## FIELD CHANGE ORDER

**Reference No.** : FCO74200019  
**Date** : March 2004  
**Product Group** : 742

### **OPTIMUS RAD / RF / C**

Low-speed rotor control power resistor exchange

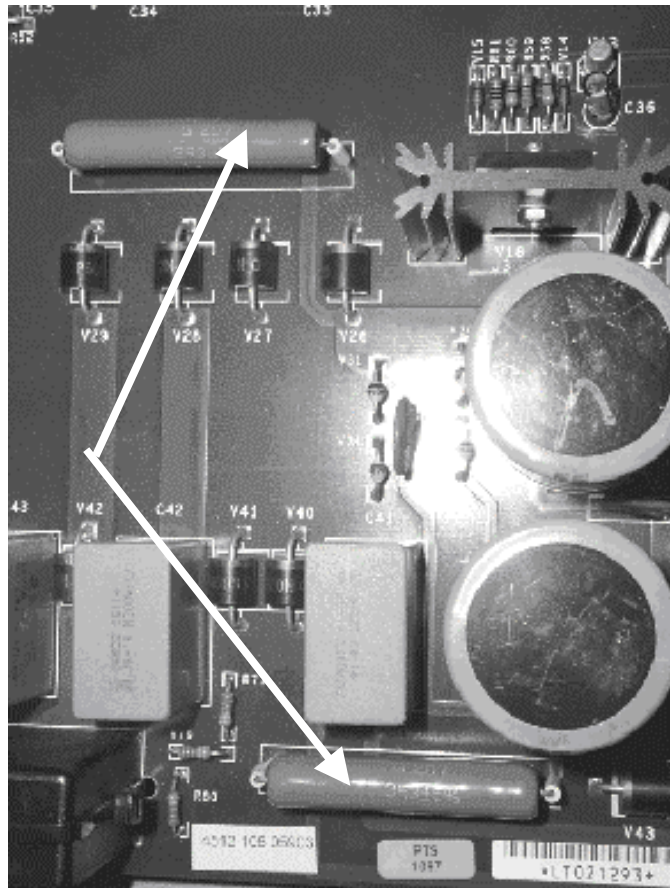
**Symptom** : Early failure or burnt smell of the resistors in the low-speed rotor control PCB EYA 100

**Cause** : The hygroscopic cementation of the resistors allows an absorption of humidity that may cause corrosion of the wires and failure of the resistors.

**Remedy** : Replacement of resistors R64 and R78 with new specially coated resistors.

- Unsolder the original resistors and remove them from the PCB.

The ceramic distance sleeves must be re-used.

The ceramic body of new resistors should not be touched.

- Insert the new resistors with two ceramic distance sleeves at each of the wire ends to keep the same distance from the PCB surface as before, resistor surface – pcb distance  $\geq 5\text{mm}$  (see photo).
- Solder on the wires and cut off the excess lengths.
